RE: Permit Modification Request for Dump 1Ea for the Dicaperl El Grande Perlite Mine; Permit No. TA002RE

Dicaperl Minerals Corp
El Grande Mine
Permit No. TA002RE
Permit Modification
Application Response

**RE: Updated Closeout Plan Application Response, Permit Modification 14-1, Permit No. TA002RE,
El Grande Mine**

Figure No. A1
WORK AREA SITE PLAN - 1EA
JANUARY 2016

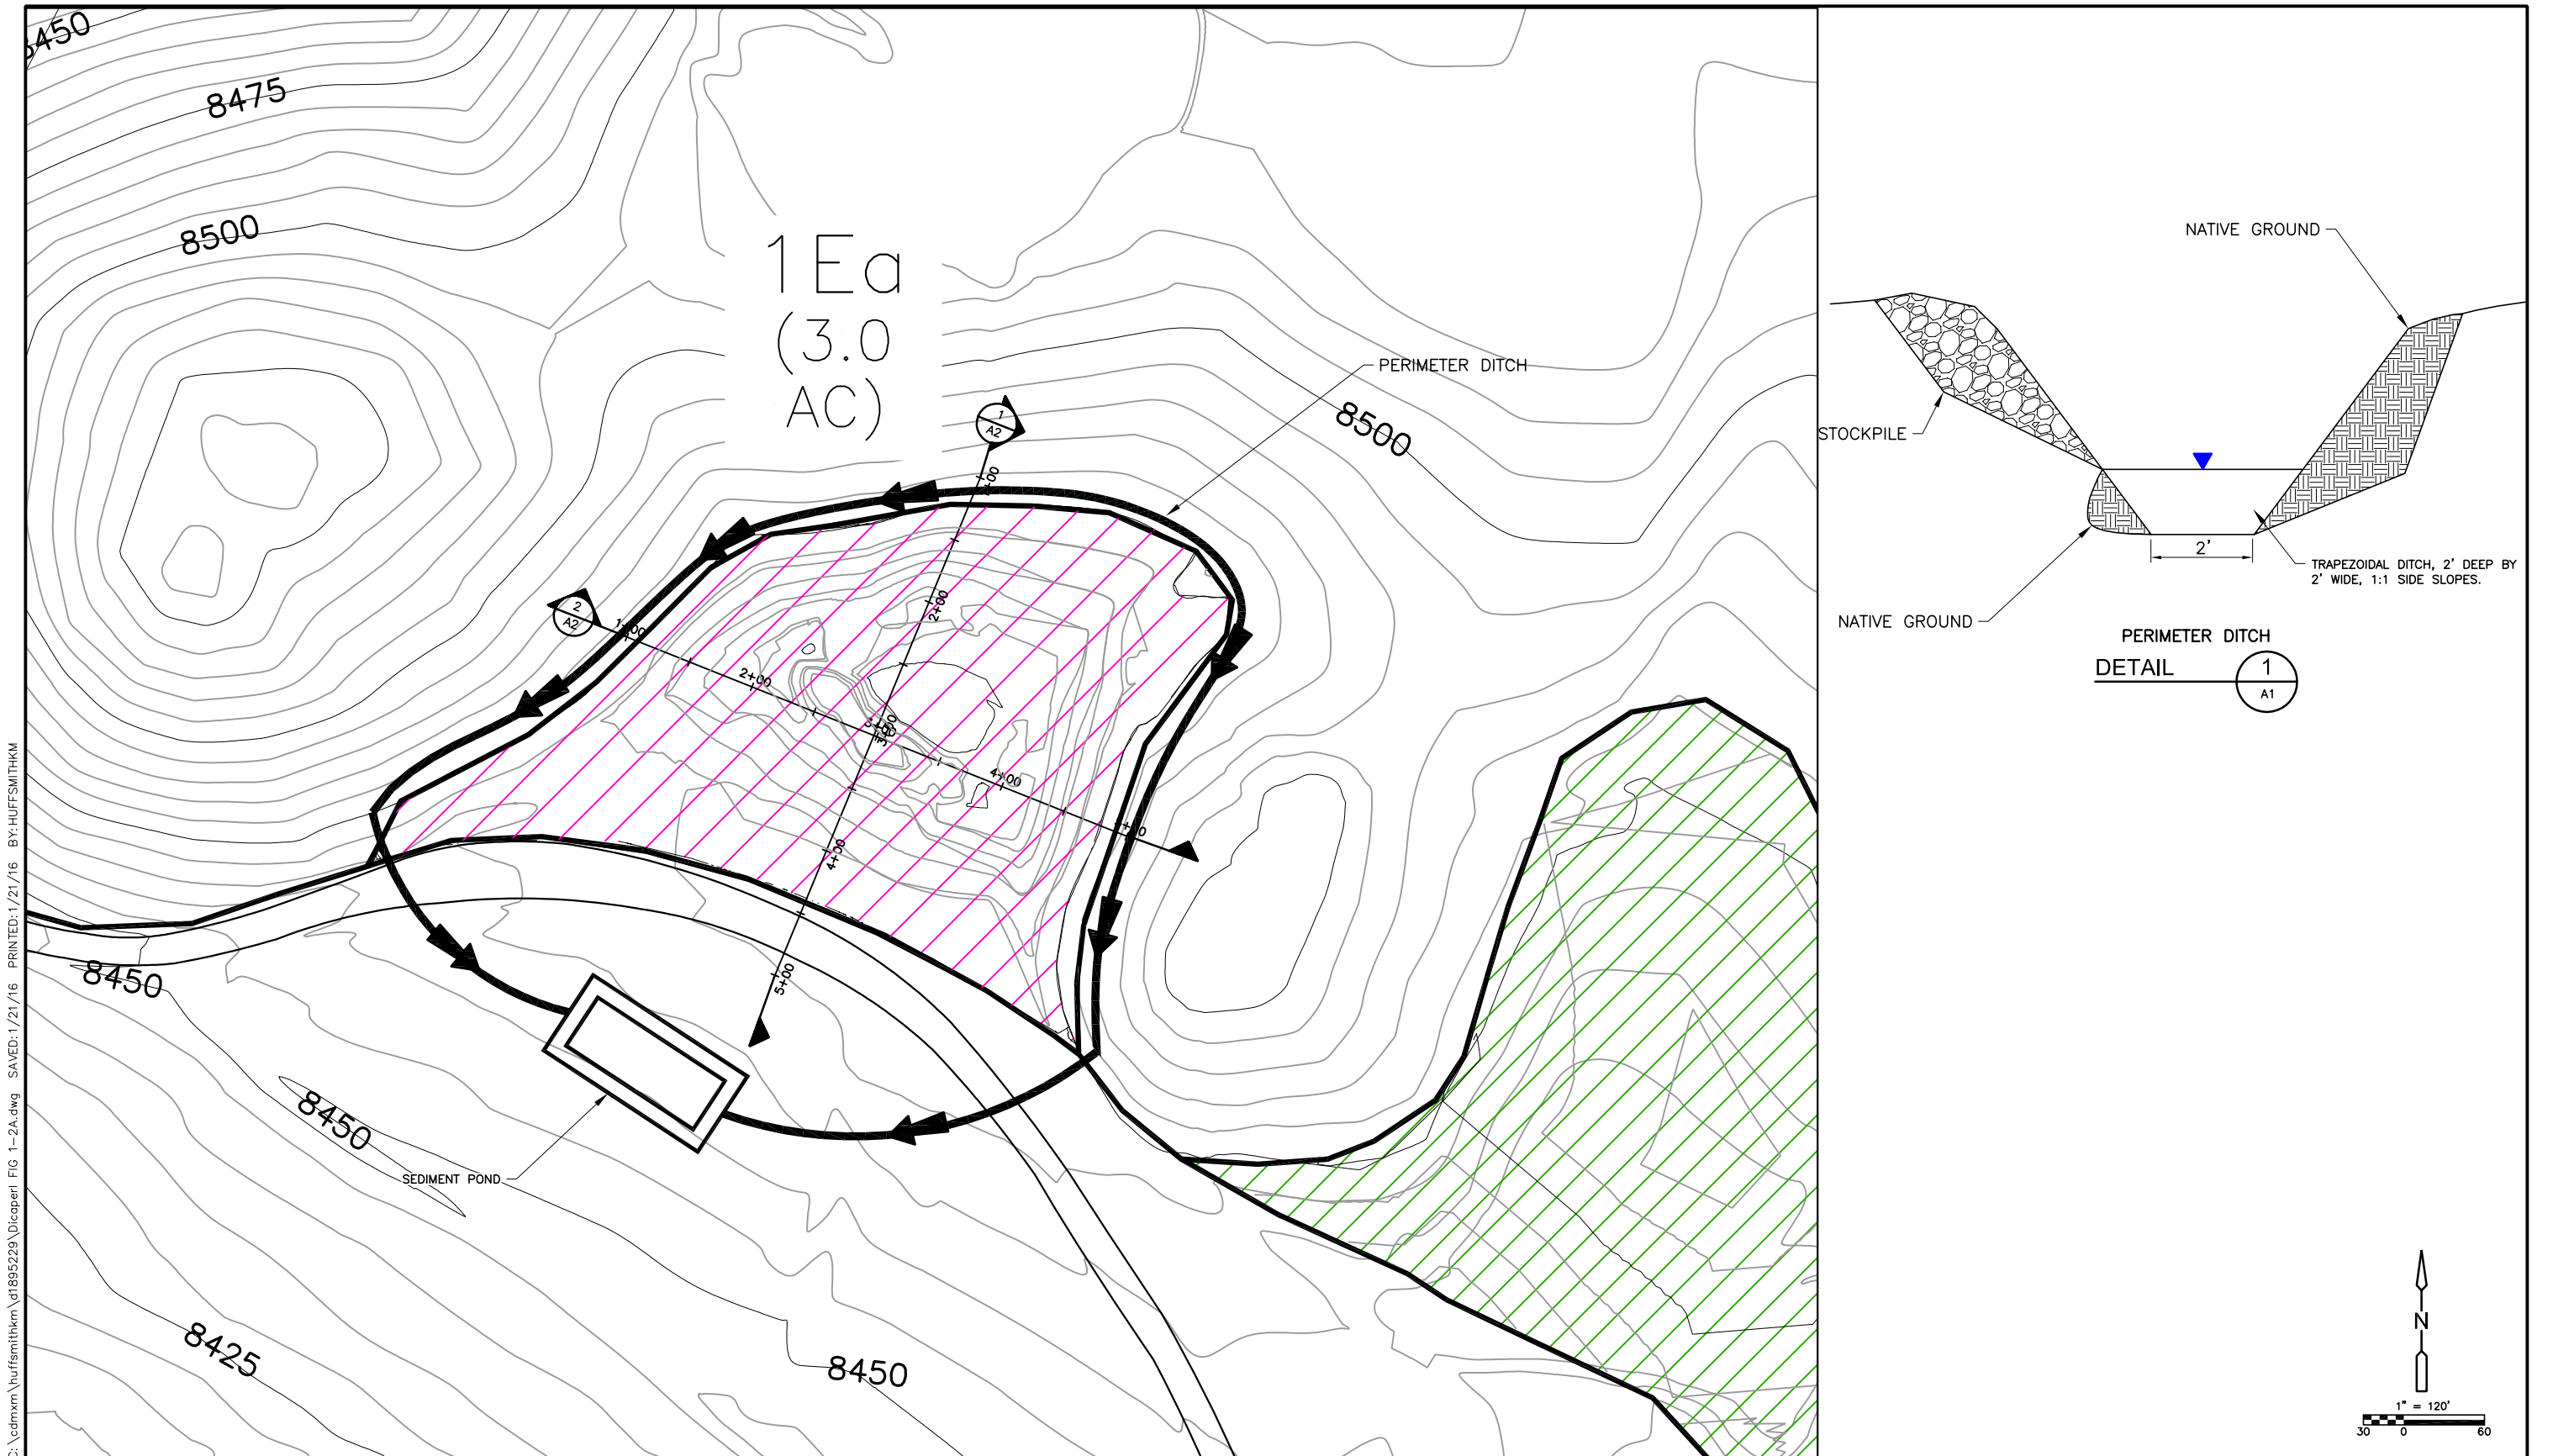
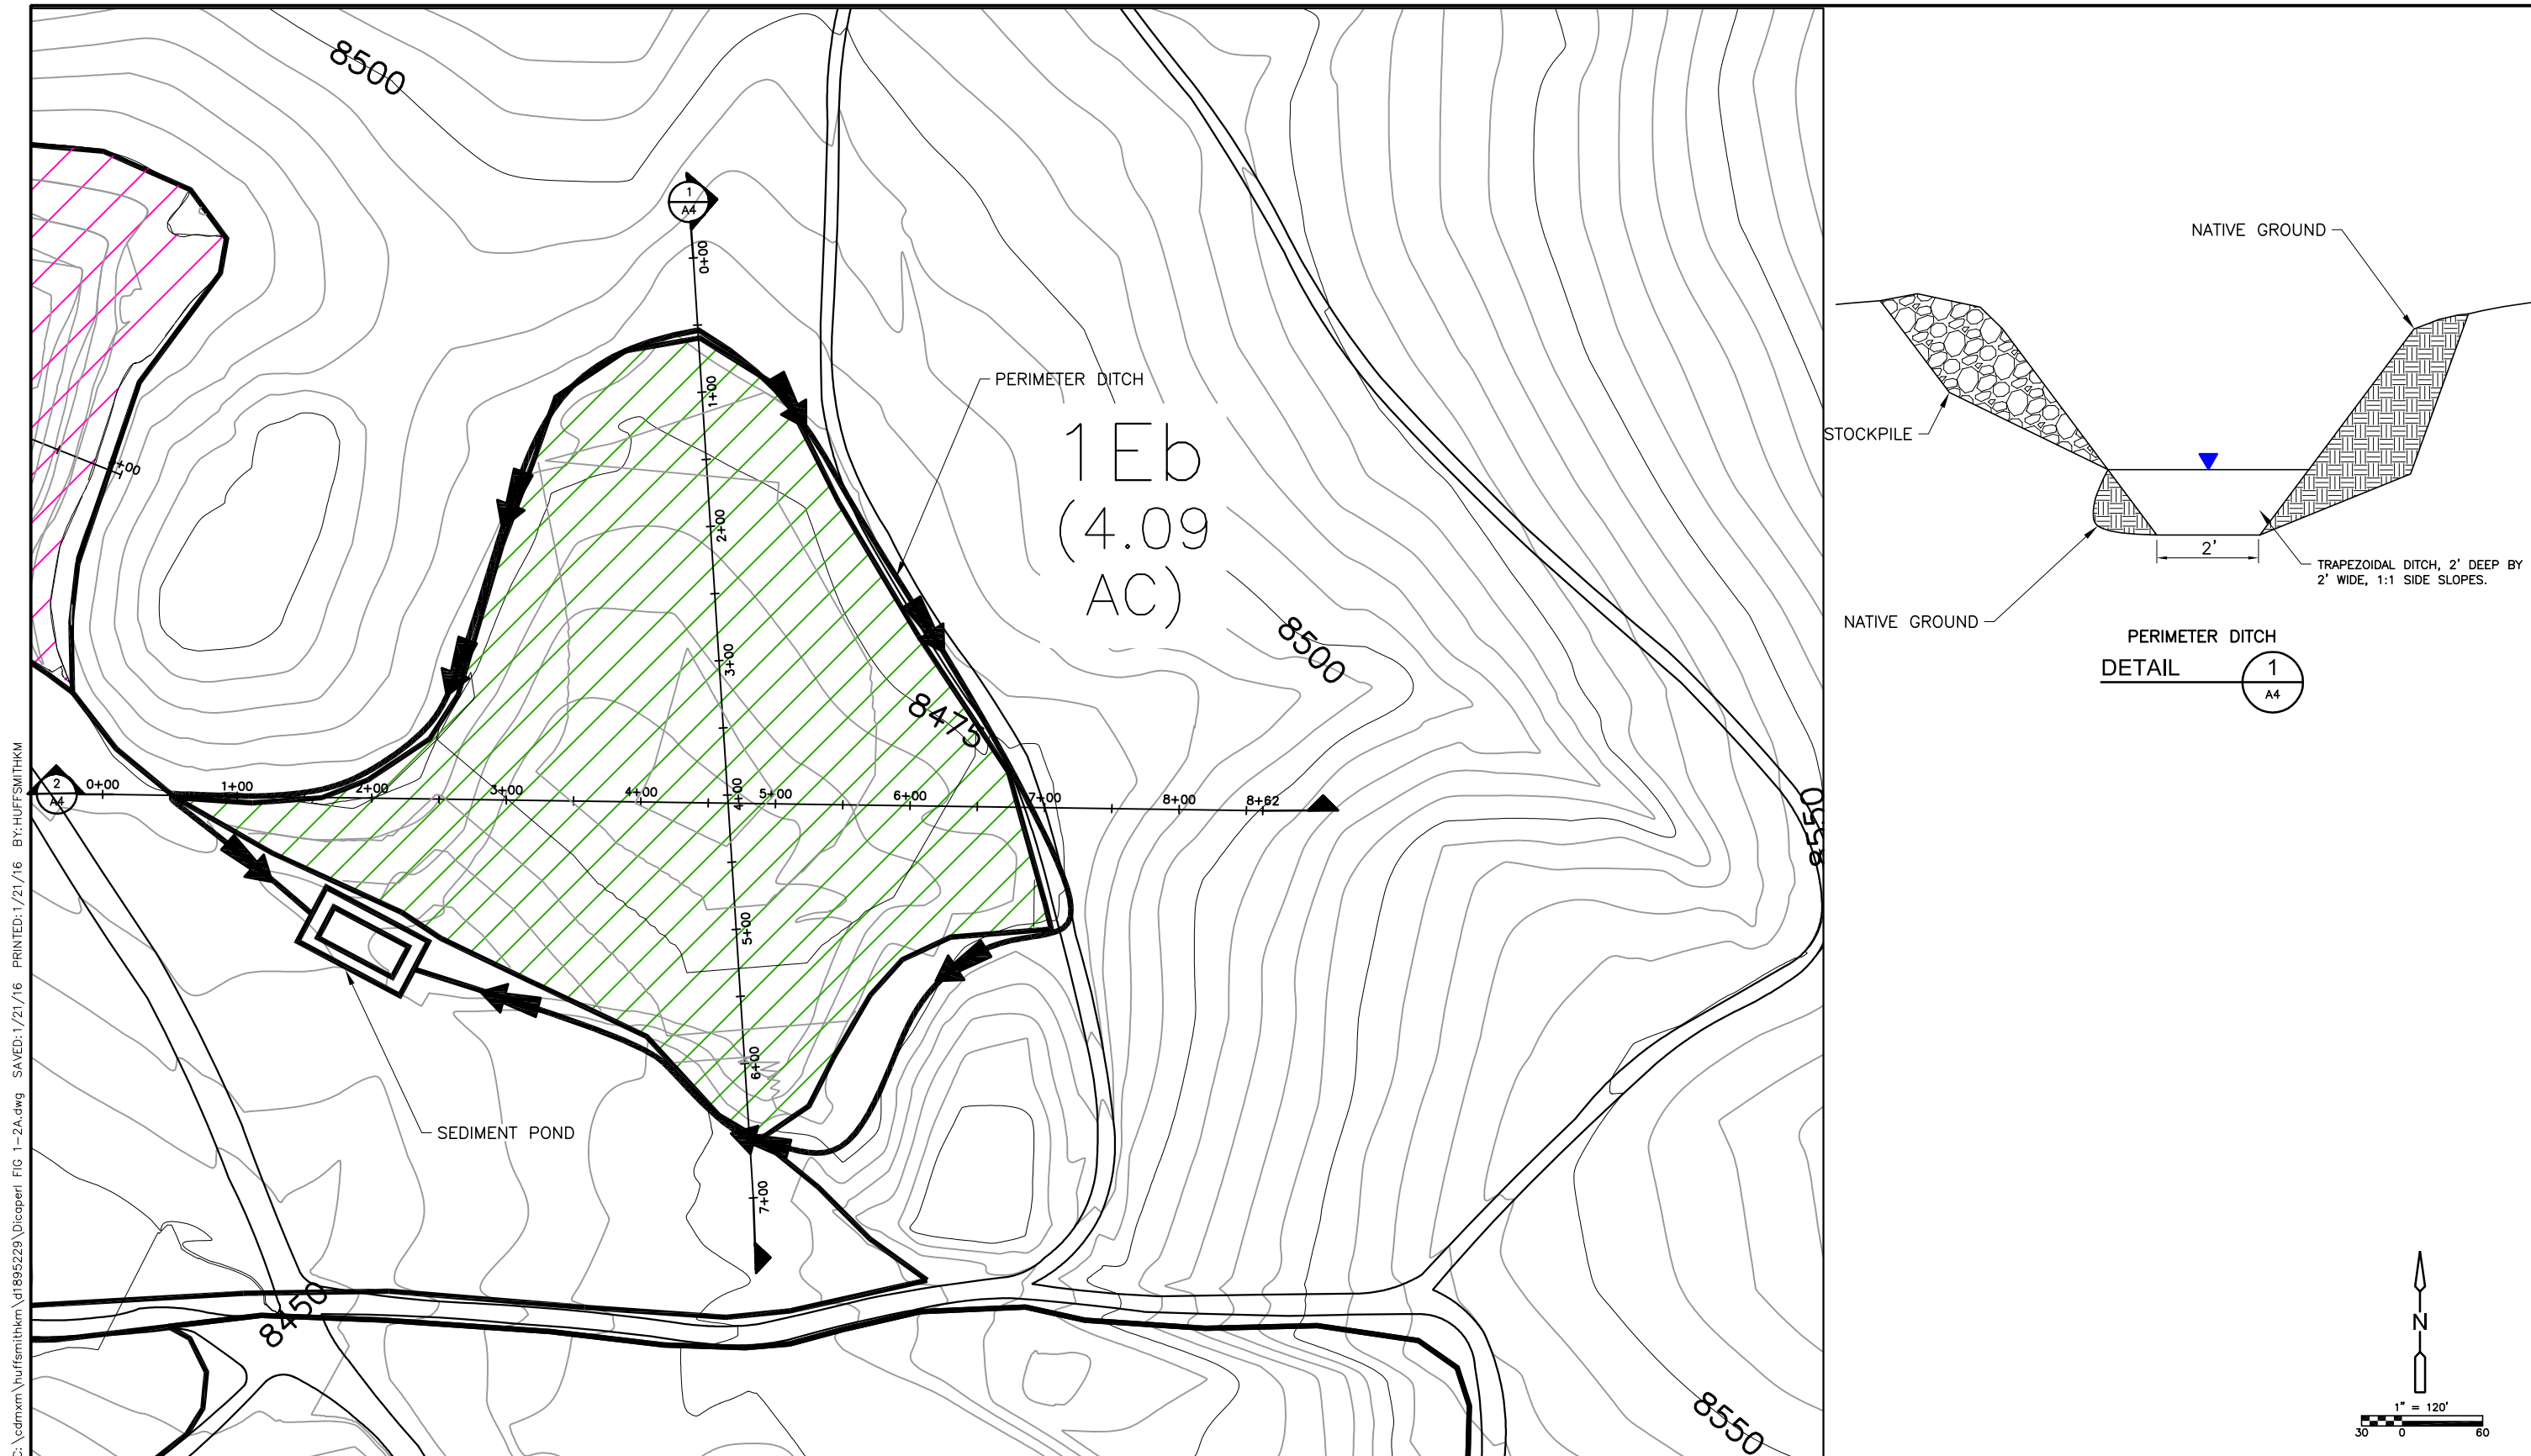
Please provide additional information: Section 3.3, Waste Receiving Plan, page 7 in the Application - states "The super sacks are covered with obsidian-rich perlite from the middle of the quarry area every 15 days or 10 truckloads. In the case of both the 1Ea and the 1Eb areas, the placement of waste will cease after the dump (and cover) elevation reach approximately 8475 feet amsl. Following completion of the dumps, they will be reclaimed in the manner described in Section 5 ". The cross-sectional drawings of the waste dumps after regrading provided in the Response for Dump No. 1E (Figure No. 5-9) do not indicate which of the 1E waste dumps are represented (1Ea, 1Eb, or 1Ee). Additionally, Figure No. 5-9 shows the final grade to be 8505 amsl while the Application states that the approximate final elevation will be 8475 feet amsl, a difference of 30feet. Please clarify which of the 1E dumps figure No. 5-9 represents and provide a minimum of two cross sectional views per dump (north-south and east-west) of the other 1E dumps and the 2A dump. Please extend the line of current existing grade on cross sectional views of dumps to show the intersection of the reclaimed (final) dump surface slope with the surrounding slopes. Additionally, please provide plain view maps of dumps 1Ea, b, c and 2A showing the post reclamation topography.

MMD requires an engineered design of the proposed dump. The Final approved design shall be signed and stamped by a New Mexico Professional Geotechnical or Civil Engineer.

Response: Figures representing Dumps 1E, 1Eb, 1Ec and future 2A were created to clarify final reclamation of the waste dumps. Figures associated with Dump 1Ea were previously submitted with the January 21, 2016 El Grande Mine Dump 1Ea submittal. Dumps 1Eb and 1Ec will be graded to the slope ratio of 3H:1V for the final configuration. The proposed future Dump 2A will follow the Dump Plan with the final slopes graded to 3H: 1V. The final elevation of Dump 1Eb and 1Ec will be a peak of 8485 ft above mean sea level (amsl) with the edges extending to 8475 ft amsl. Future Dump 2A will reach a final peak of 8500 ft amsl with the edges extending to 8475 ft amsl. See attached Appendix A Reclamation Design Figures for revised cross sections of Dumps 1E, 1Eb, 1Ec and future Dump 2A for final grading configuration.
